Subject: Yapton Y/71/20/RES & Y/72/20/RES

Subject: RE: Yapton_Y/72/20/RES - 70 units

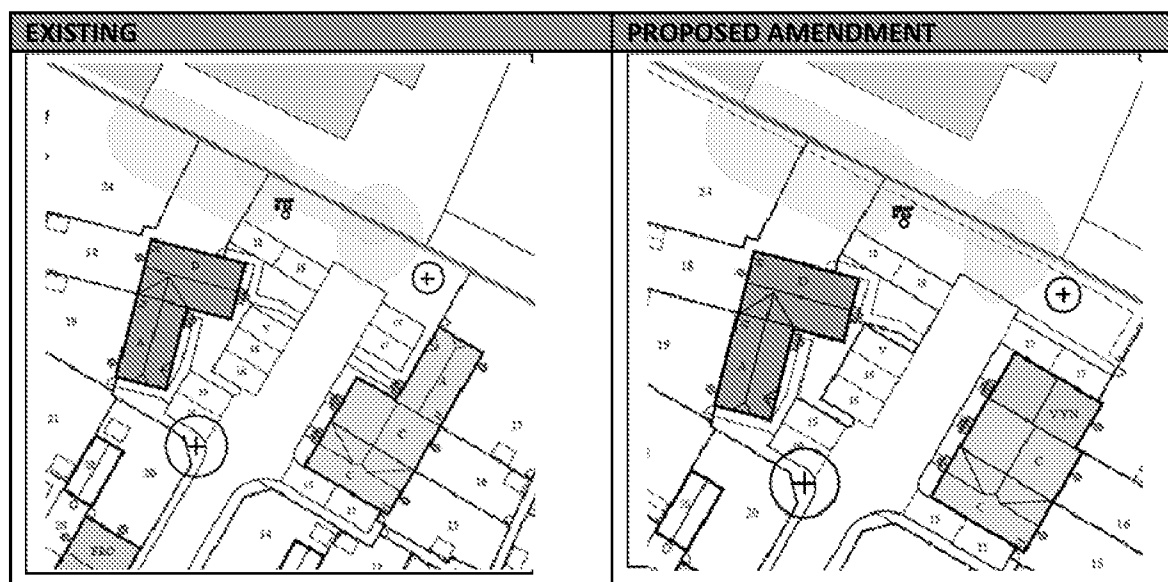
We're in the process of amending plans and particulars to account for the comments received, hope to have updates with you next week. Changes are limited with only one amendment which would impact the street scene. This is on the 38 unit scheme where Plot 17 has been amended. This had been a wide fronted dwelling as shown below though to account for amendments to the distribution of the affordable units the plot has been turned. Would you have any objections in principle to the change?

I have no objections in principle to the change to plot 17 although I think the existing arrangement offers a more visually interesting streetscene at the end of the cul-de-sac.
